# **CONNECTION ASSESSMENT & APPROVAL PROCESS**

*Project: Midhurst TS: Establish a Second 230kV DESN*

***CAA ID No. 2003-EX130***

#### *Midhurst TS - Establish a 2nd 230/44kV DESN Station*

**Proposed Expansion of Midhurst TS**

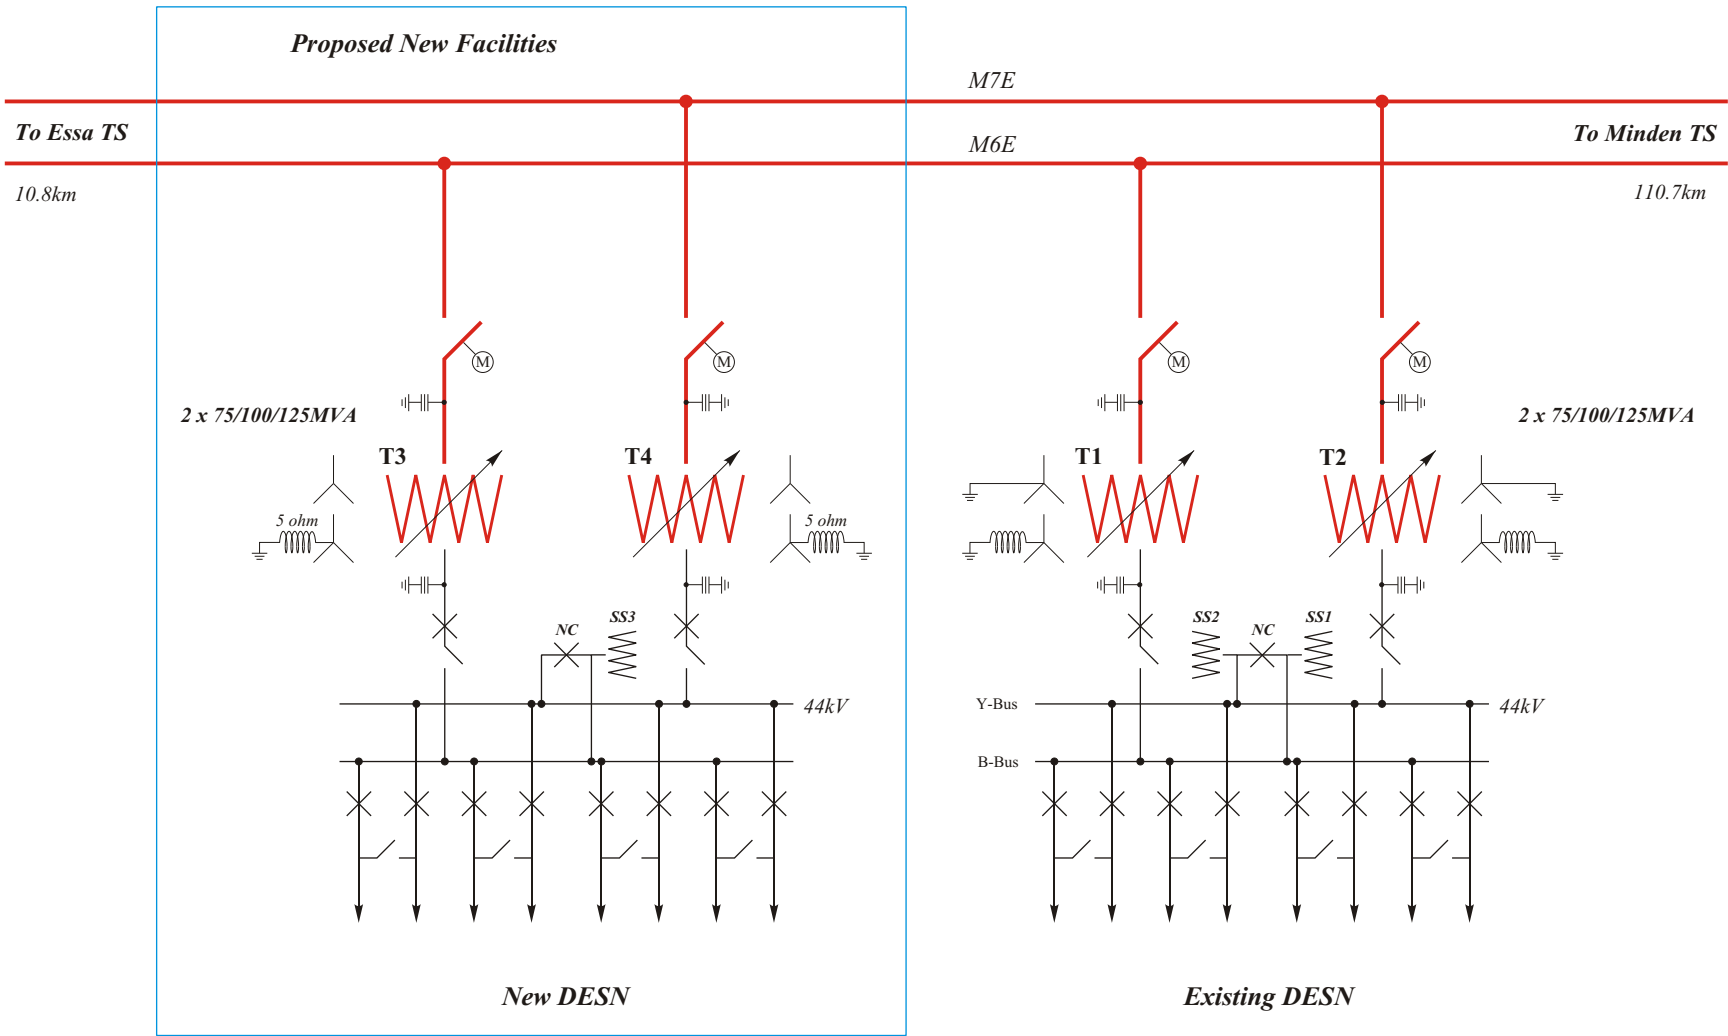
Diagram 2 provides details of the 44kV busbar arrangement at the new DESN station, with a normally-closed bus-coupler breaker interconnecting the two 44kV busbars. The development is to include eight 44kV feeder positions.

It is therefore required that provision be included in the plan to develop Midhurst TS for the installation of shunt capacitors.

**Load Flow Study Results for the Summer-2006 Peak Condition: Extreme Weather Load Forecast**  
 With all Transmission Elements In-service

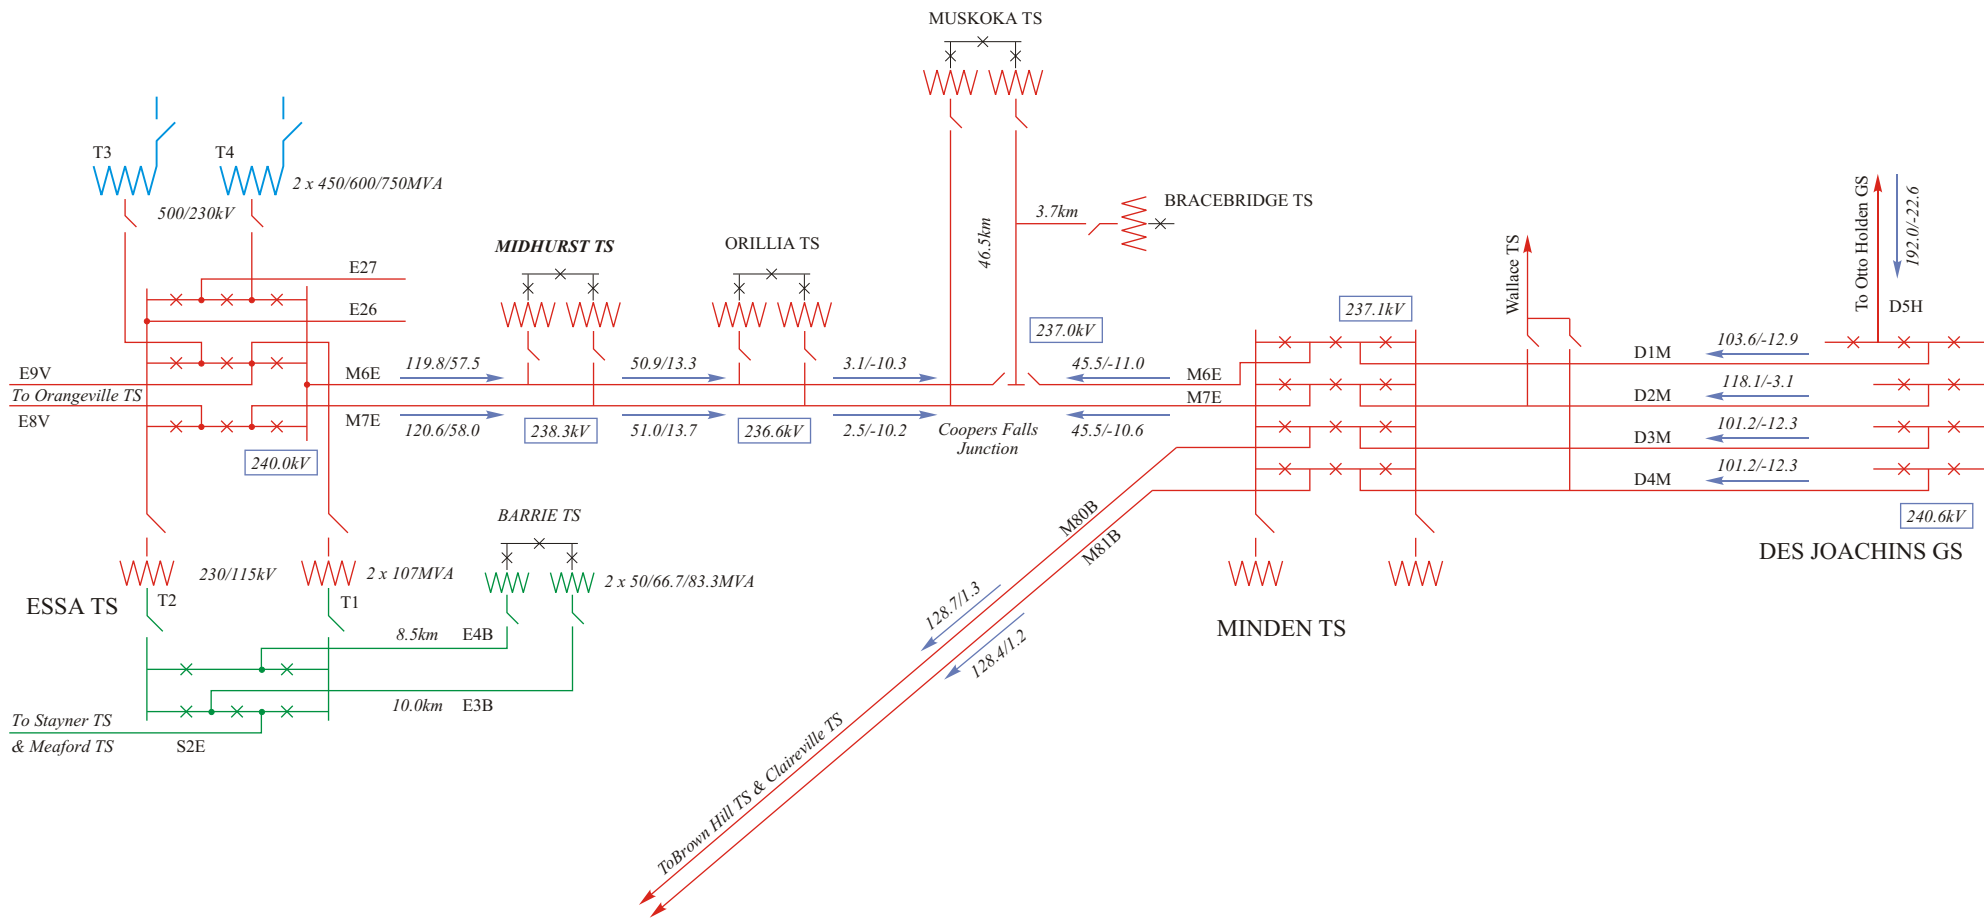
Diagram 3 shows the normal flow distribution, with all transmission elements in-service.

This shows that the flows on the section of circuits M6E & M7E between Orillia TS and Coopers Falls Junction are normally close to zero.

This means that the loads at Midhurst TS and Orillia TS are normally supplied from Essa TS, while the remaining loads at Muskoka TS, TCPL Bracebridge TS, Wallace TS & Minden TS, together with some of the loads associated with circuits M80B & M81B, are normally supplied from Des Joachims GS.

For an 'extreme weather' peak value of approximately 265MVA for the loads at Midhurst TS and Orillia TS, the flow on the section of each circuit between Essa TS and Midhurst TS (of ~ 135MVA per circuit) would be well within its continuous thermal rating (of 360MVA).

**Load Flow Study Results for the Summer-2006 Peak Condition: Extreme Weather Load Forecast**  
 With circuit M6E out-of-service

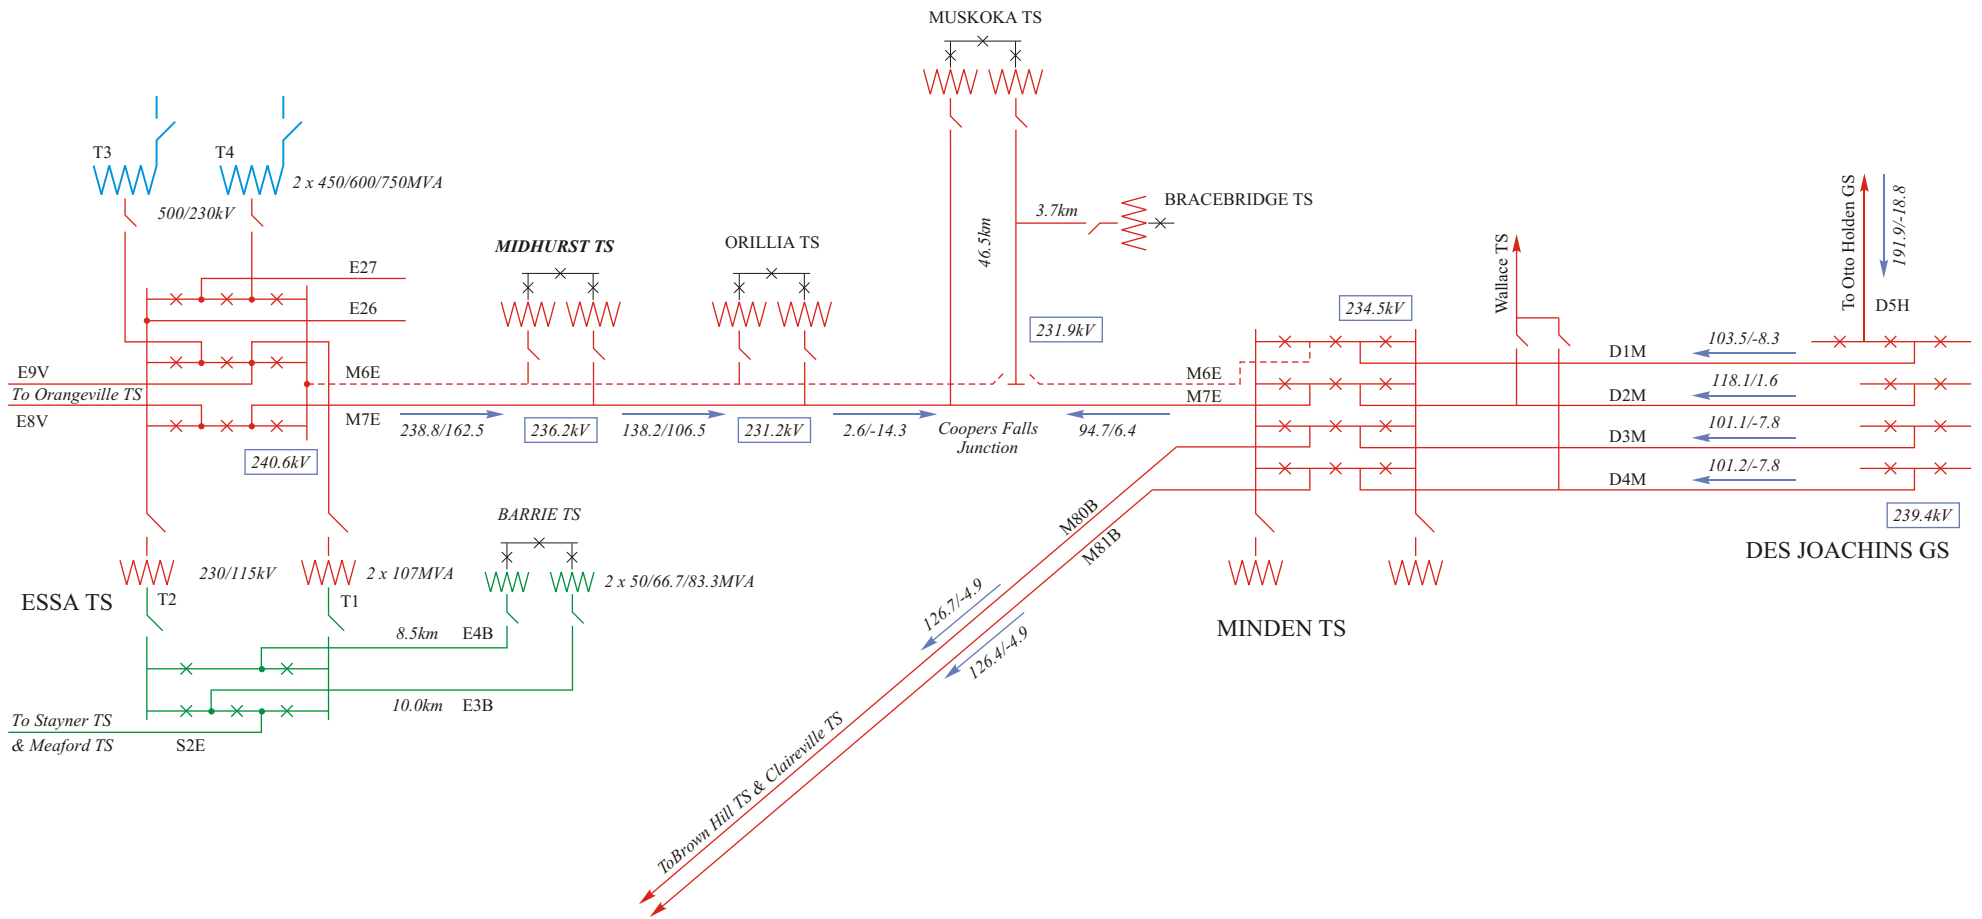
Diagram 4 shows the corresponding flow distribution with the 230kV circuit M6E out-of-service.

This shows that the flow on the companion circuit over the section between Essa TS and Midhurst TS (of ~290MVA) would remain well within the continuous rating of the circuit.

Furthermore, the post-contingency voltages, following tap-changer action, show a decline of less than 3%, which would be within the IMO's criteria.
